# PRODUCT SAFETY

## ADVISORY

**PRODUCTS AFFECTED:** FJ175

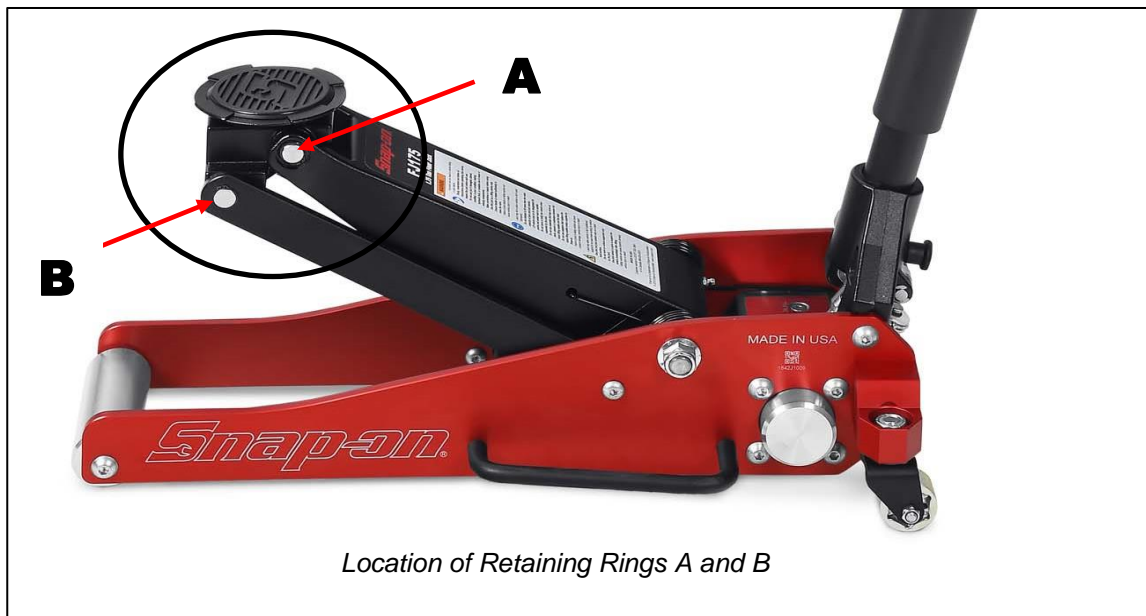
**HAZARD:** There is a potential that the retaining rings holding the saddle mount pivot pins were not installed correctly. There is also a potential that the front pivot pin groove is not deep and/or wide enough. This may cause the pivot pins to slide out of position which could cause the jack to lose stability under load leading to personal injury and/or property damage.

**ACTIONS:** Inspect the retaining rings to ensure they are intact and fully seated in the pin grooves. Inspect each of the four locations as shown. If any of the retaining rings noted as 'Not OK' on page 2 and 3 of this advisory, order FJ175RRKIT Retaining Ring and Pivot Pin Replacement Kit. The kit contains one Pivot Pin (B) and four Retaining Rings. Pin A does not need to be replaced. Note the FJ175KIT is Lifetime Warranty. Return the original Pin B and Retaining Rings to the RPC for full credit.

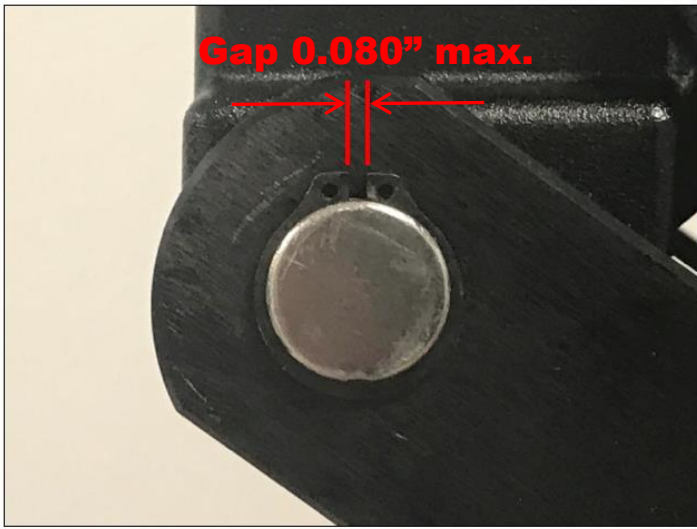
**OK**

**Not OK**

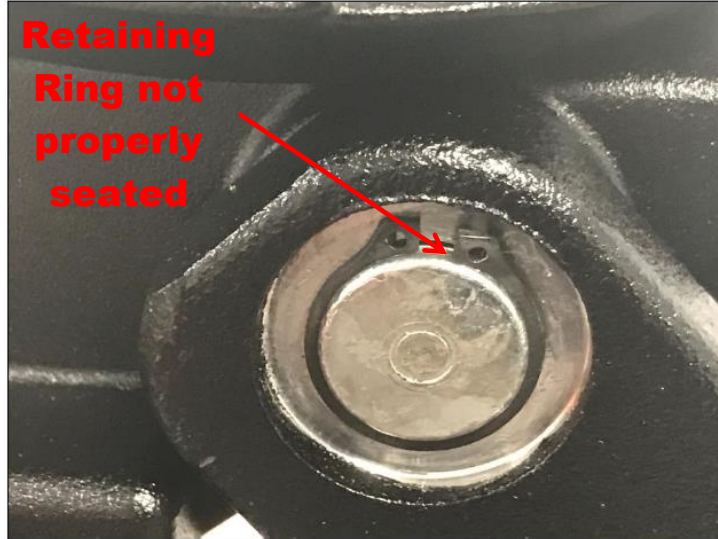
**OK**

**Not OK**

**OK**

**Not OK**

**OK**

**Not OK**

Note: it is not necessary to orient the snap ring with the tangs up.
